SERVICE BULLETIN

CHECKING OF THE CRANKCASE

ON ROTAX® ENGINE TYPE 912 AND 914 (SERIES)

SB-912-029 R2
SB-914-018 R2

Bild / Fig. 1

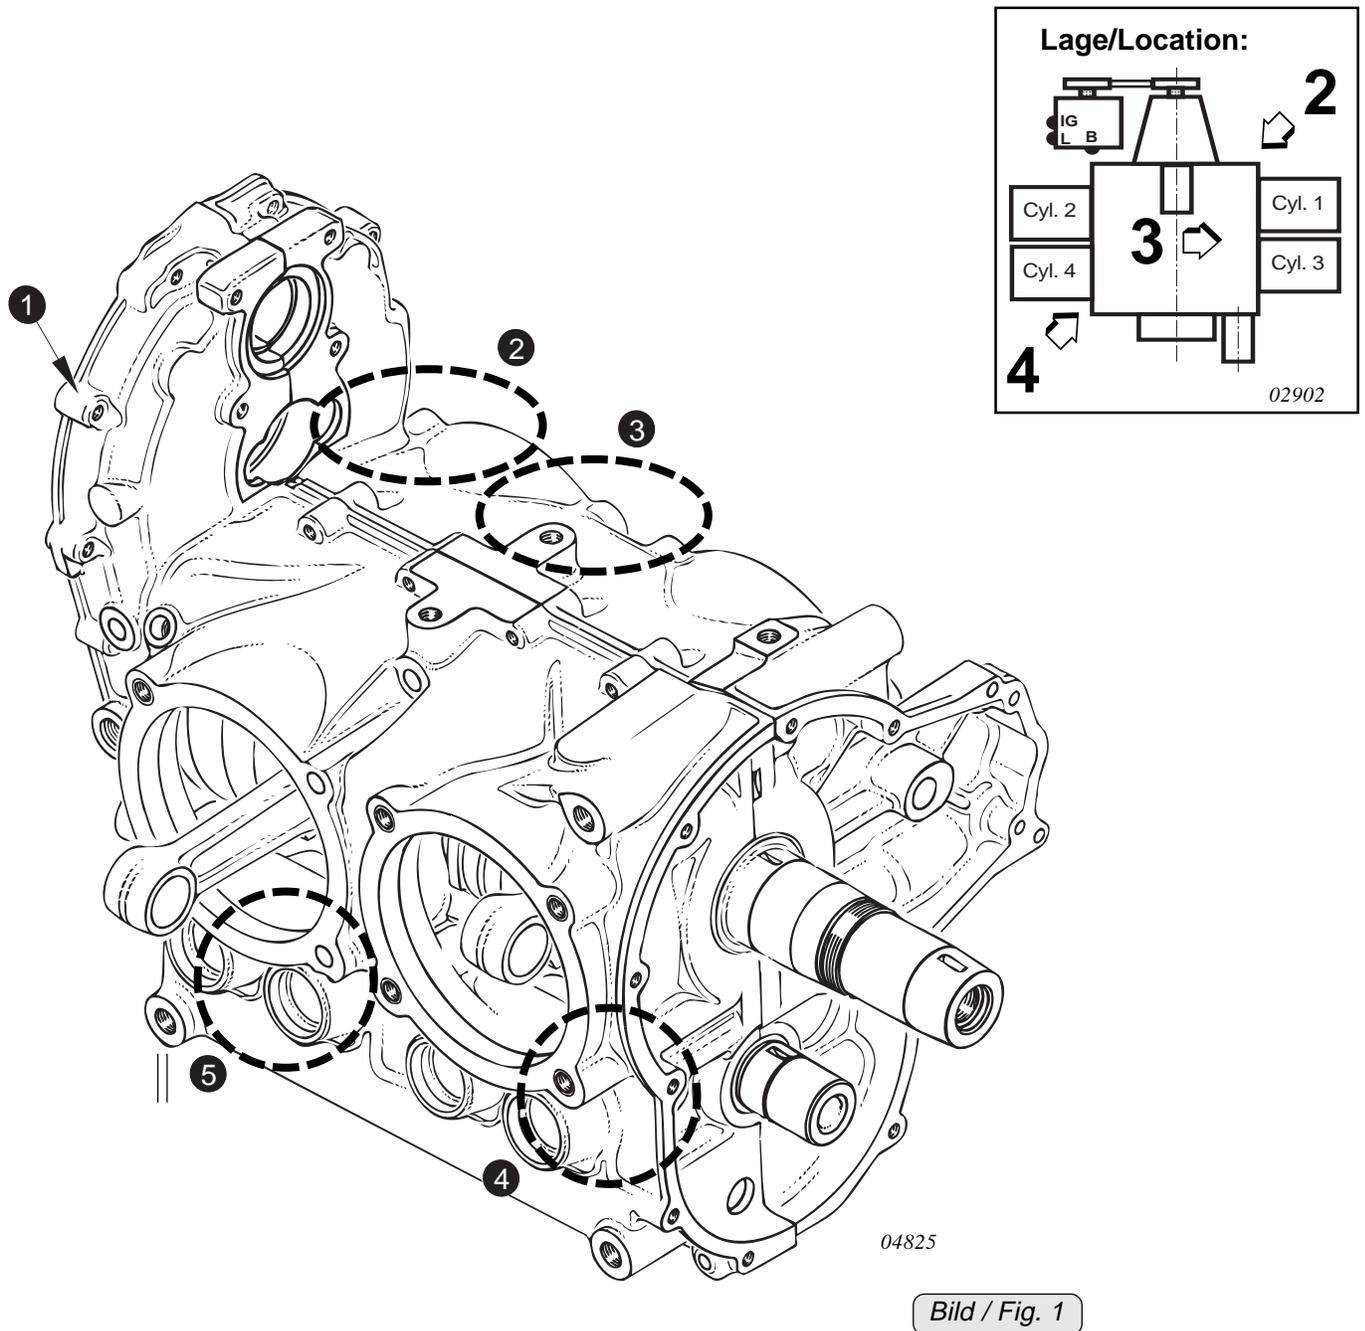
see fig. 1

- Visually inspect the crankcase (1) and engine suspension for cracks in accordance with the relevant Maintenance Manual.

◆ **NOTE:** Scrutinize the crankcase for cracks especially in the area of cylinder 1 upper side (2), between cylinder 1 and 3 upper side (3), cylinder 4 lower side (4) and between the hydraulic valve tappet hole (5) of cylinder 2. See fig. 1.

For those engines using the ROTAX[®] cooling air baffle. Visually inspect for oil leaks in area (2) and (3). If leaks are found, then further investigation to determine the cause of the oil leak is required. If the exact origin of the leak can not be determined i.e. governor, then removal of the cooling air baffle may be required.
